QUESTIONS AND ANSWERS

**COMPETITION FOR THE CONCEPTUAL ARCHITECTURAL DESIGN OF
THE BASE STATION FOR THE „HAJLA AND ŠTEDIM“ SKI CENTER**

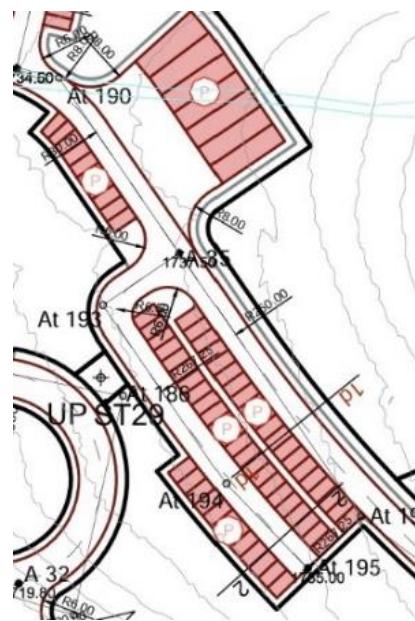
Is there a set number for the underground parking lot?

The ratio of underground to above-ground parking spaces is defined by the design solution. See the answer to question No. 16.
